Access Compliance Report

Public Rights-of-Way

Intersection ID: 48243	Main Street: YELLOWSTONE_SPRINGS_LN	Cross Street: NORMANS_LANDING_DR	Location: SW
ADA ID: 2A1483AEEC21	Ramp Type: PerpDiag	Initial Pass/Fail: Fail	Overall Compliance: No
Codes/Mitigation Info/Possible Solution		Field Measurements/Component Compliance	
Severity Score: 13.75

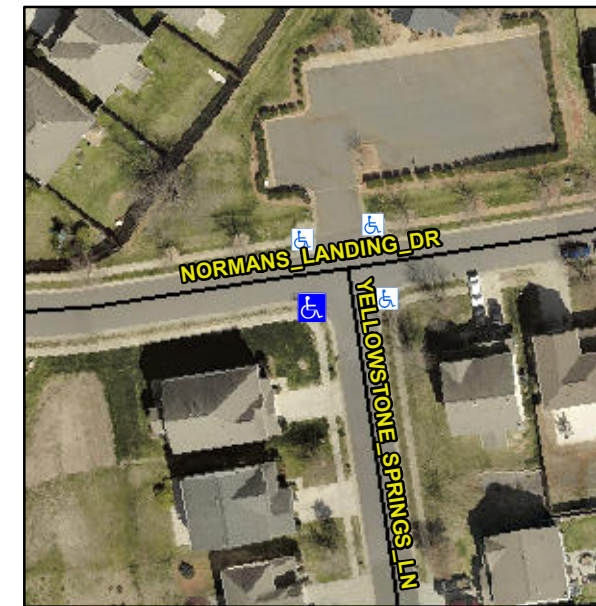
R304.2.2, R304.5.3

Compliance	Description	Data	Compliance	Description	Data
N/A	Ramp Length (in)	50.0	No	Ramp Slope (%)	10.1
Yes	Ramp Width (in)	48.0	No	Ramp XSlope (%)	2.3
N/A	Flare Type LT	N/A	N/A	Flare Type RT	N/A
N/A	Flare Slope LT (%)	N/A	N/A	Flare Slope RT (%)	N/A
N/A	Flare Traversable LT?	N/A	N/A	Flare Traversable RT?	N/A
N/A	Landing Length (in)	N/A	N/A	DWS Provided?	N/A
N/A	Landing Width (in)	N/A	N/A	DWS Contrast?	N/A
N/A	Landing Slope (%)	N/A	N/A	DWS Length (in)	N/A
N/A	Landing X Slope (%)	N/A	N/A	DWS Full Width?	N/A
N/A	Landing Curb? (Y/N)	N/A	N/A	DWS Offset (in)	N/A
N/A	Shared Landing?	N/A			
N/A	Gutter Ponding?	N/A	N/A	Gutter Slope (%)	N/A
N/A	Gutter Lip Ht (in)	N/A	N/A	Gutter X Slope (%)	N/A
N/A	Painted X Walk1?	No	N/A	Painted X Walk2?	No
	X Walk 1 Direction	To E		X Walk 2 Direction	To N
N/A	X Walk 1 Width (in)	N/A	N/A	X Walk 2 Width (in)	N/A
	X Walk 1 Slope (%)	3.0		X Walk 2 Slope (%)	1.8
	X Walk 1 X Slope (%)	0.8		X Walk 2 X Slope (%)	3.8

N/A	Ramp inside XWalk1?	N/A	N/A	Ramp inside XWalk2?	N/A
	Road Slope (%)	2.4	N/A	Clear Space?	N/A
	Road X Slope (%)	3.3	N/A	Clear Space to XWalk (in)	N/A
N/A	Any Obstructions?	N/A	N/A	Storm Grate/Utility Hazard?	N/A
	Obstruction Type			Storm Grate/Utility Type	
		N/A			N/A
		Yes		Surface Condition? (G/P)	Good

Remove & Replace Curb Ramp With Two New Directional Ramps or Equivalent.
